UNITED STATES PATENT AND TRADEMARK OFFICE

APPLICATION NO.	FILING DATE	FIRST NAMED INVENTOR	ATTORNEY DOCKET NO.	CONFIRMATION NO.
10/646,986	08/20/2003	Hsi Hui Yu	4062CG	1145
7590	07/02/2004		EXAMINER	
Hsi Hui YU P.O. Box 63-99 Taichung, 406 TAIWAN				NGUYEN, PHONG H
				ART UNIT
				PAPER NUMBER
				3724

Office Action Summary	Application No.	Applicant(s)
	10/646,986	YU, HSI HUI
	Examiner	Art Unit
	Phong H Nguyen	3724

DETAILED ACTION***Specification***

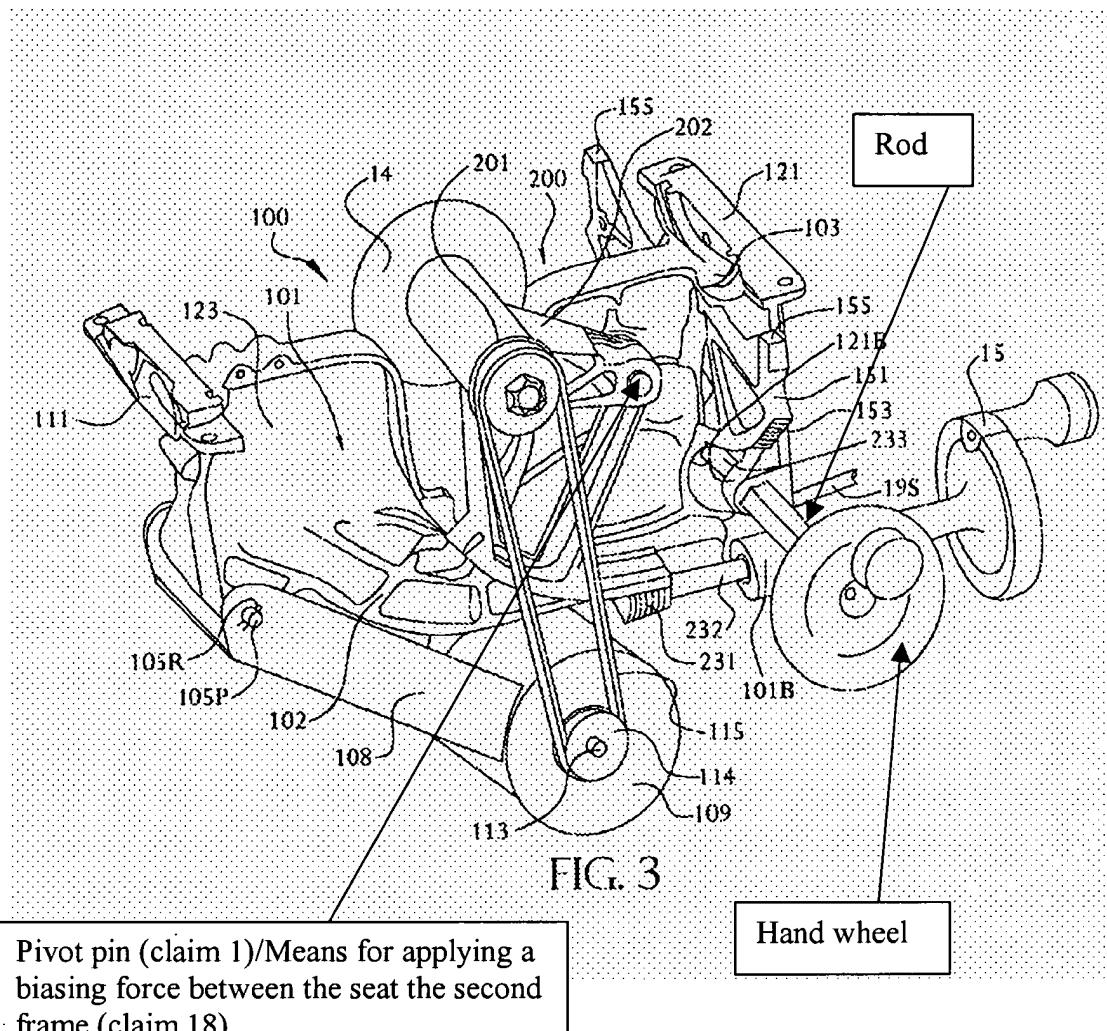
Regarding claim 10, a conduit 15S on the second adjusting means in best seen in Fig. 18. It is noted that the first saw assembly and the second saw assembly are substantially the same

Regarding claim 11, a hand wheel 15C secured to the conduit is best seen in Fig. 18.

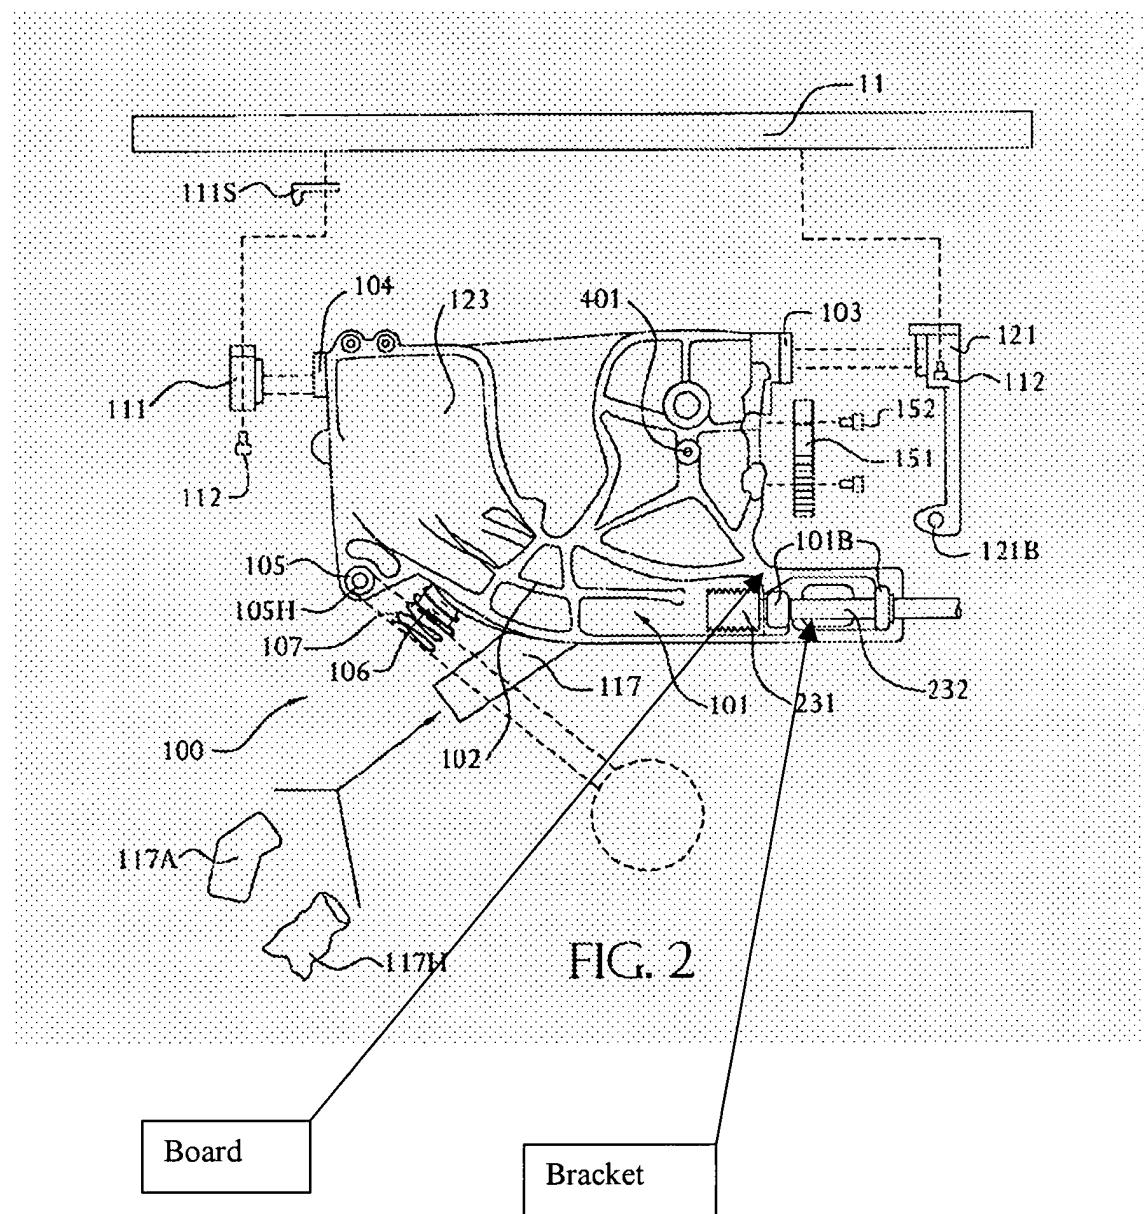
Regarding claim 12, the motor 109 for each saw is best seen in Fig. 3.

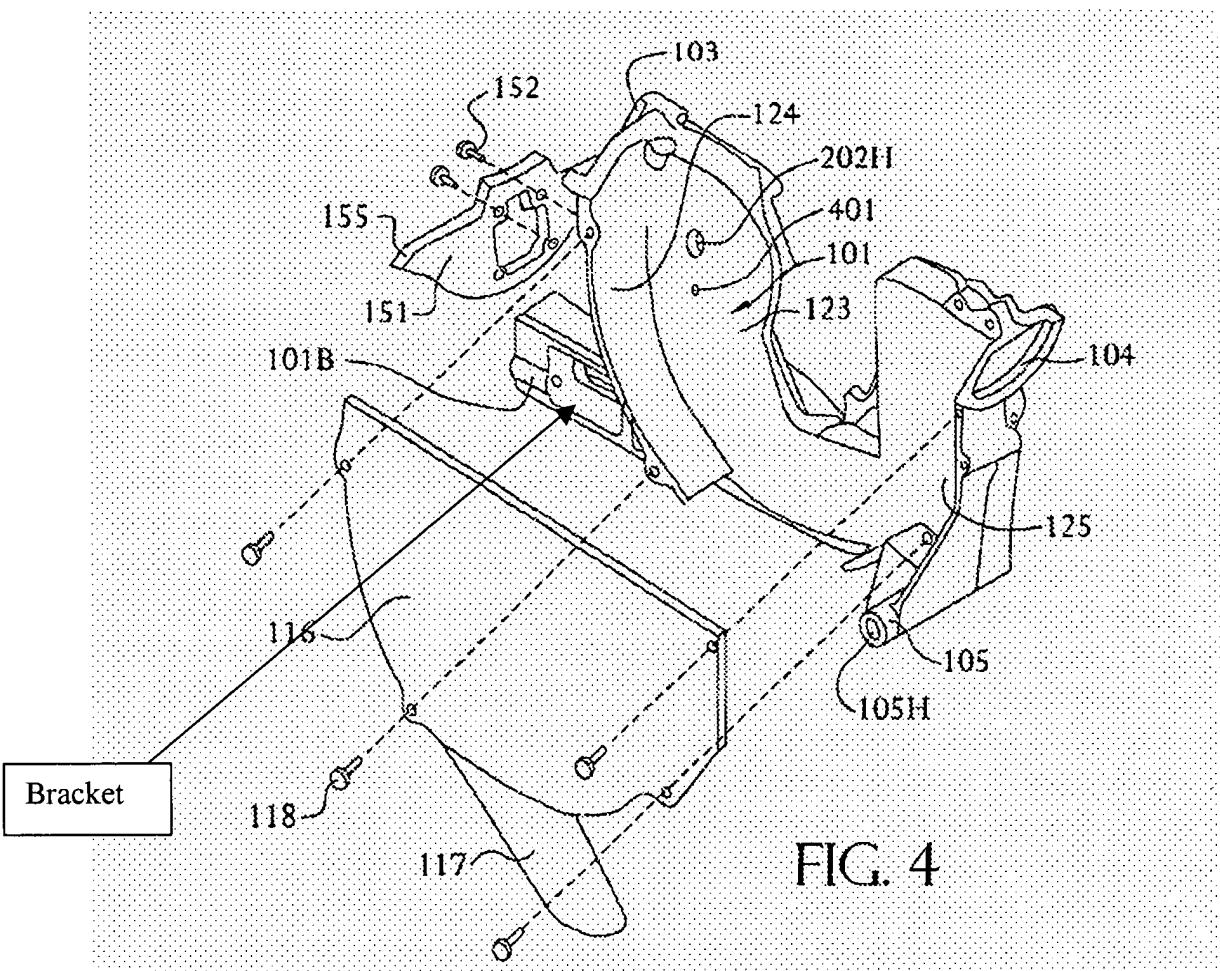
Regarding claim 13, the second adjusting means having a shaft 232 rotatably secured to a seat and a worm 231 disposed on the shaft is best seen in Fig. 3. Parks fails to teach whether the shaft 232 is solid or hollow. One having ordinary skill in the art at the time the invention was made would have been motivated to make a hollow shaft (conduit) for reducing weight of the shaft.
